ADDENDUM NO. 2

Colton MS Pavilion Building Addition

Colton Joint Unified School District
1212 Valencia Drive
Colton, CA 92324

DSA #04-123039

WEST ELEVATION

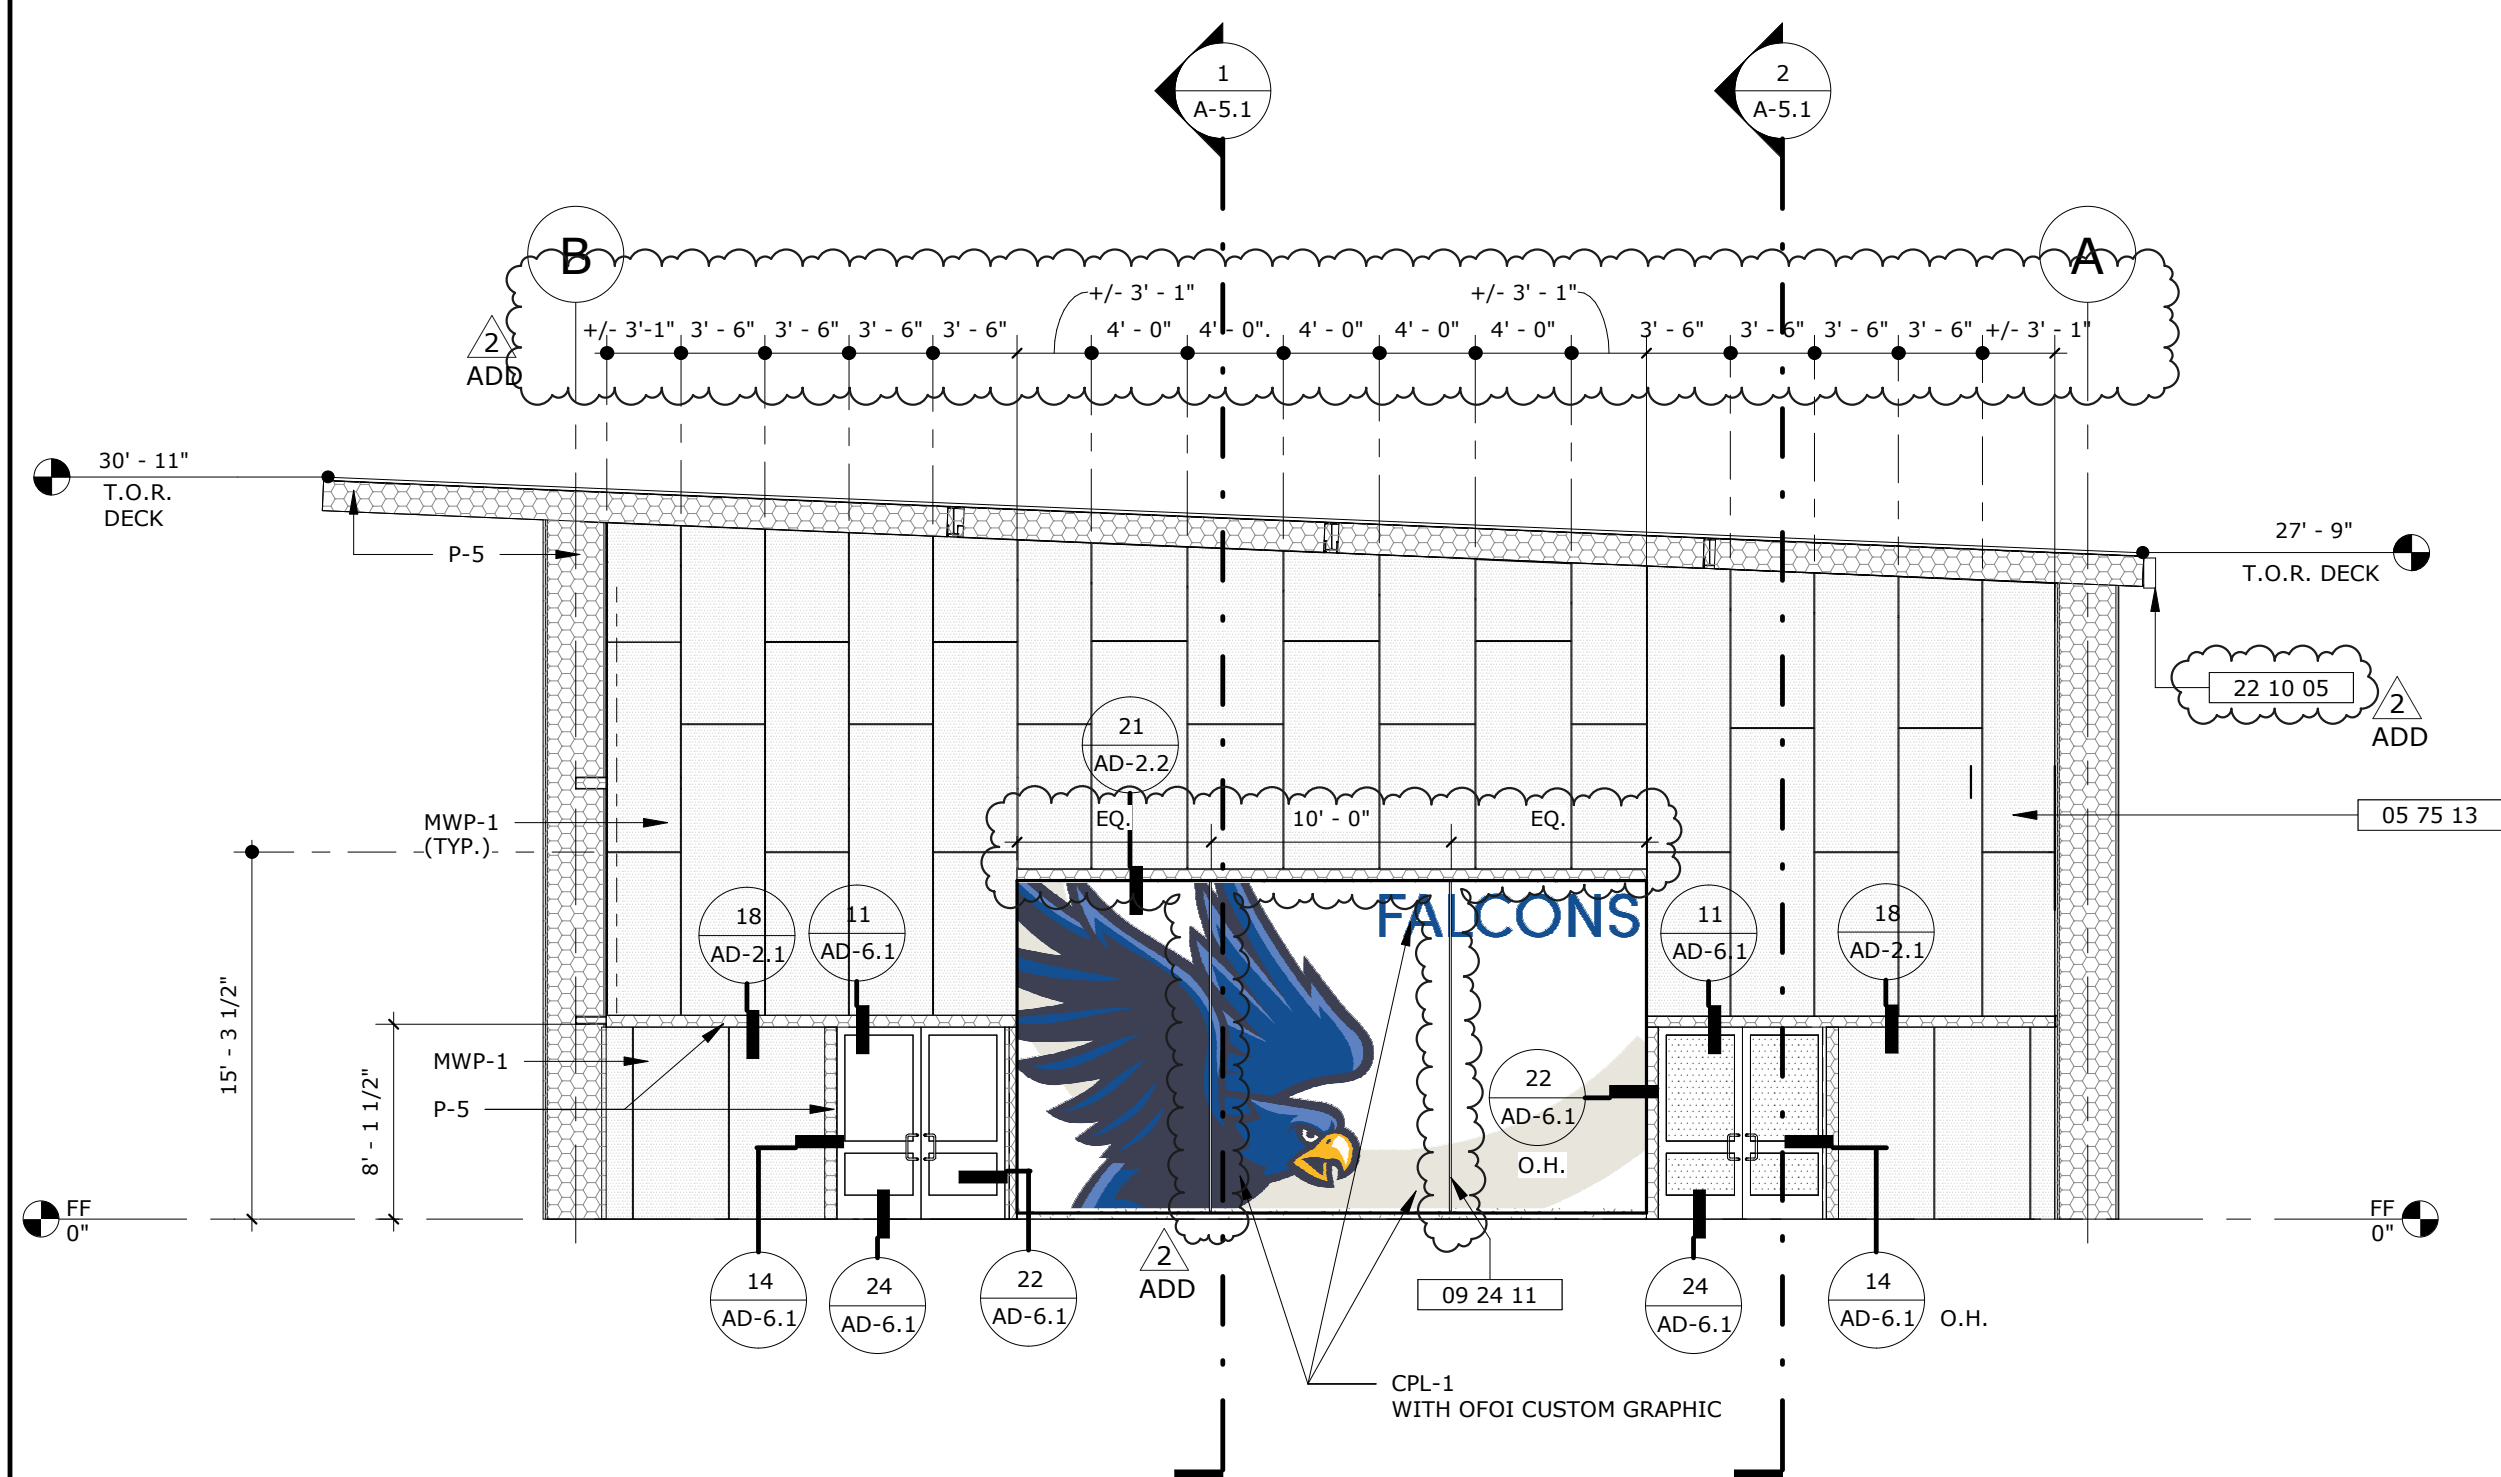
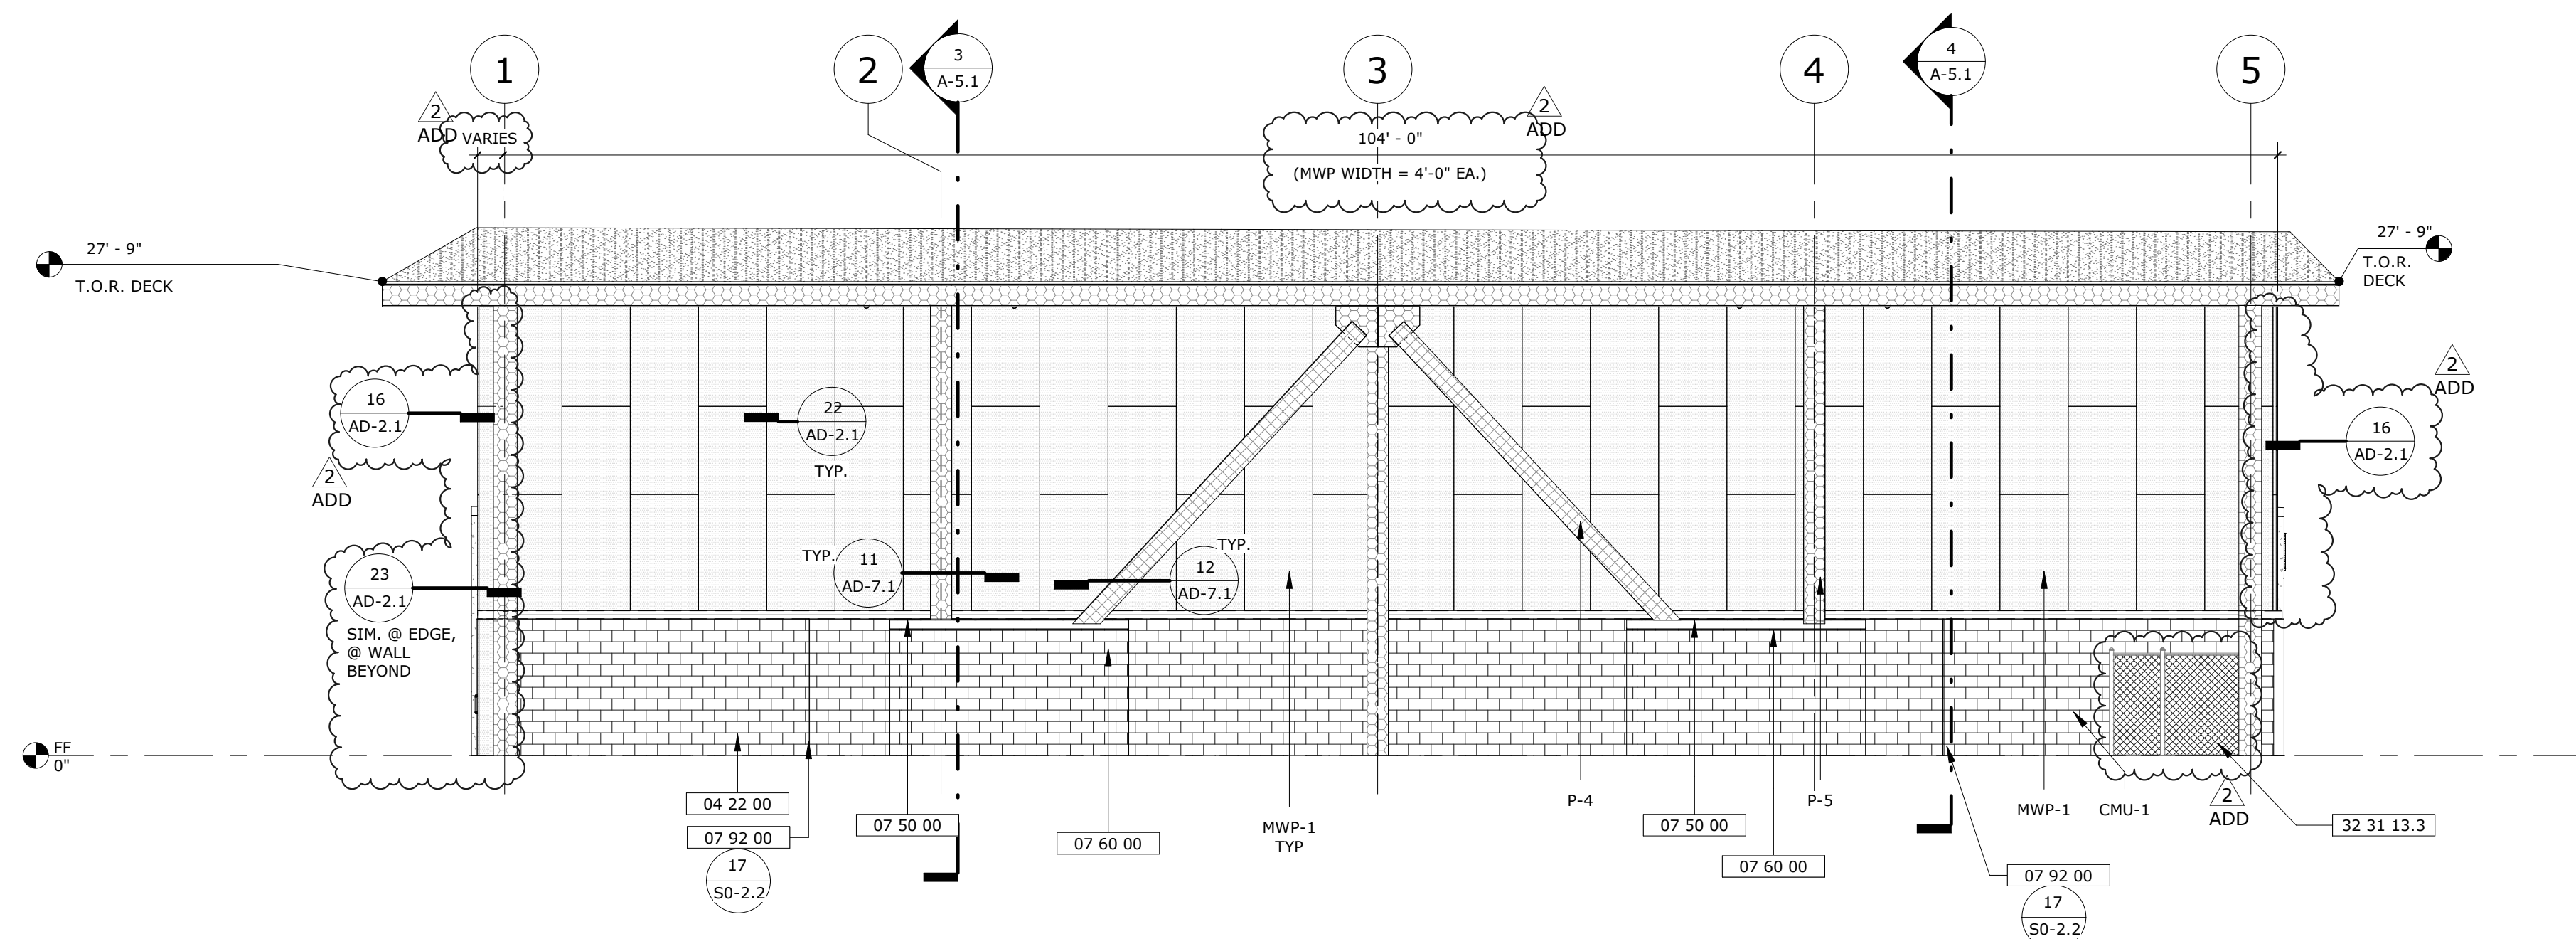
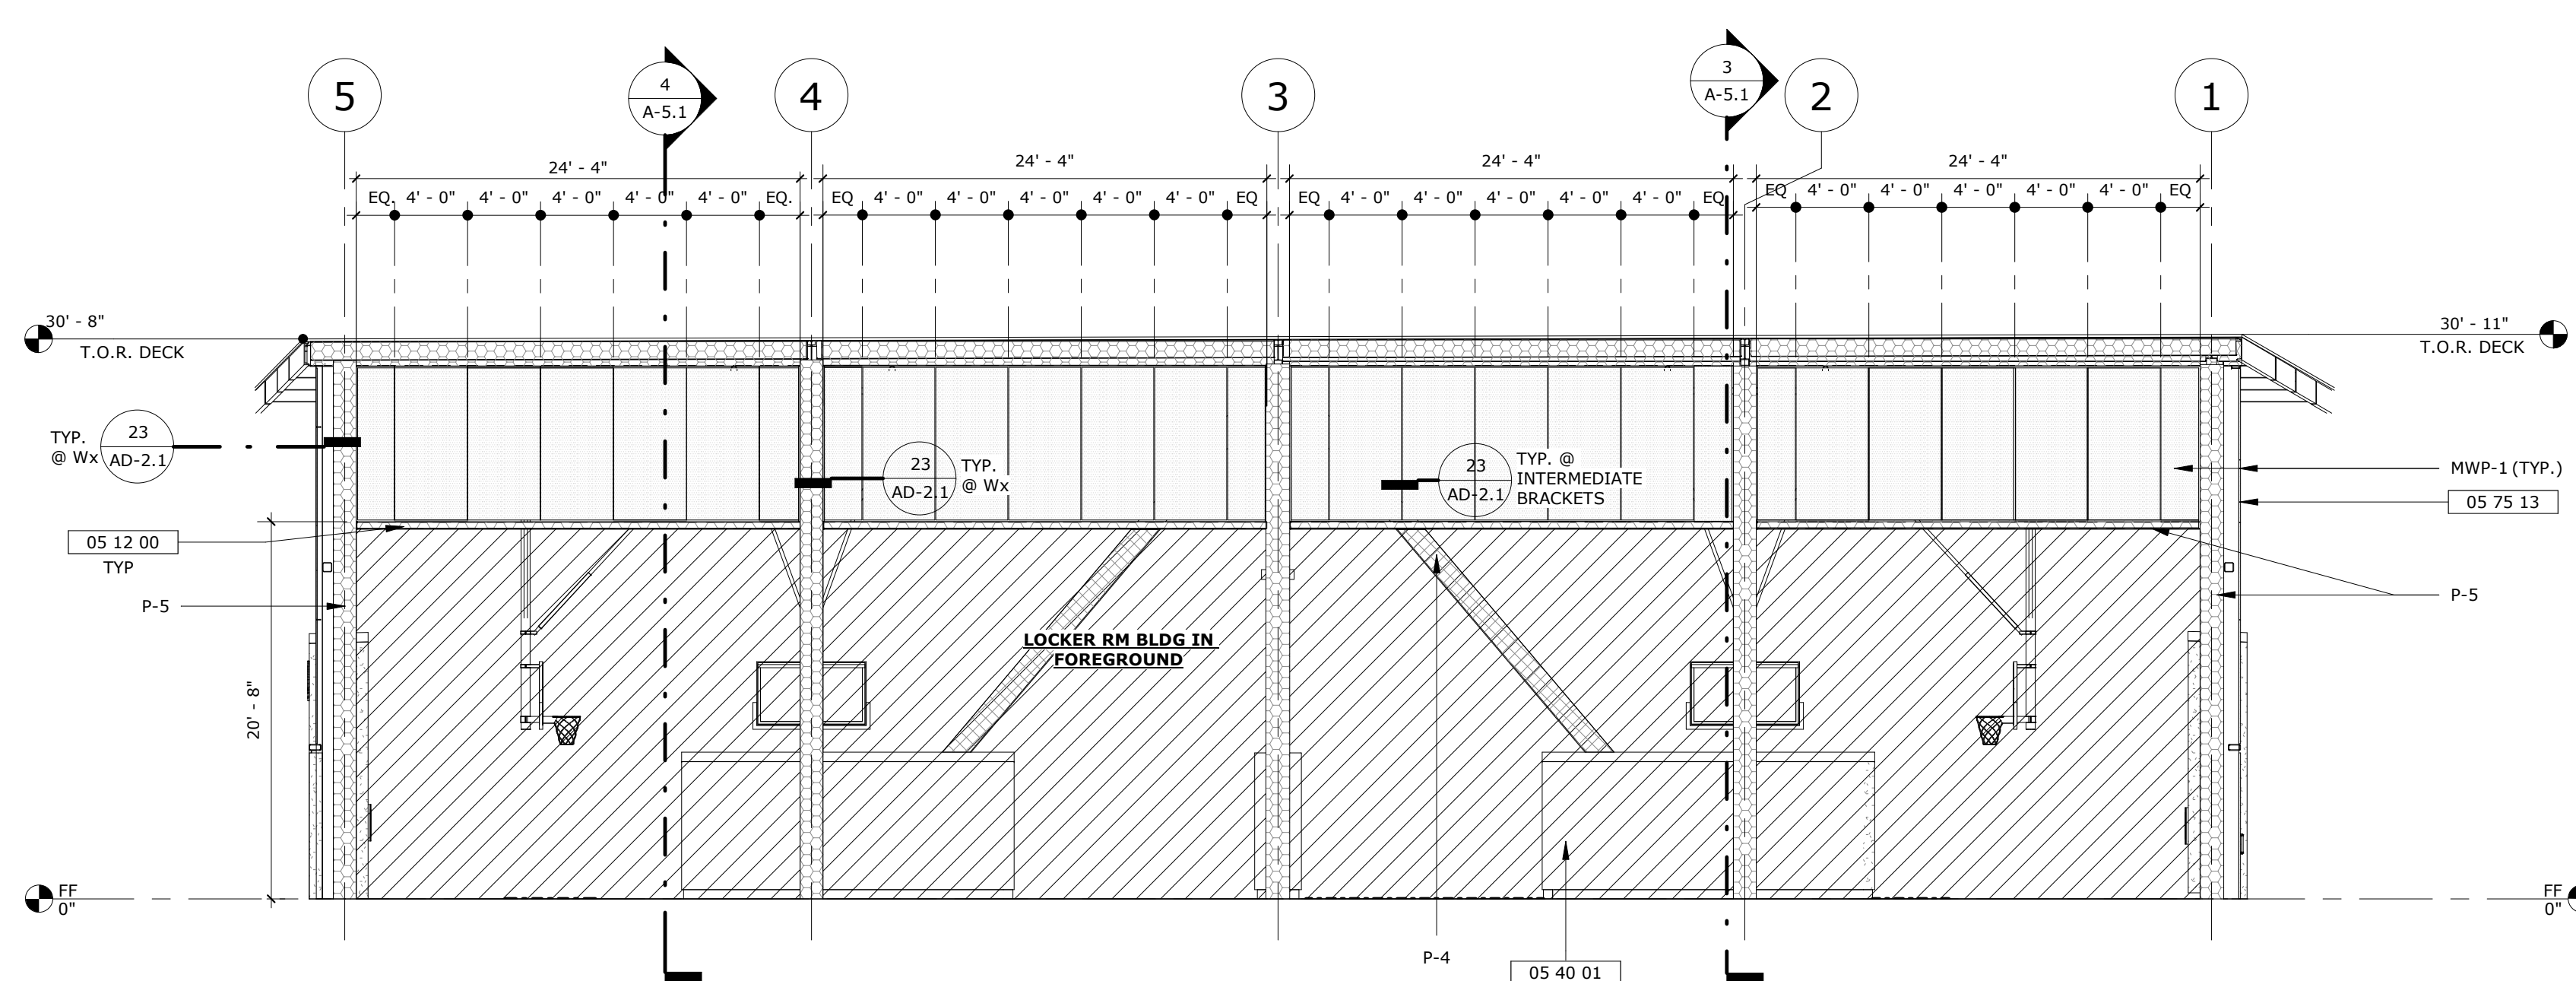
| 2.6.1 | Revised Keynotes and Details 1, 2, 3 & 4 per clouded areas. |
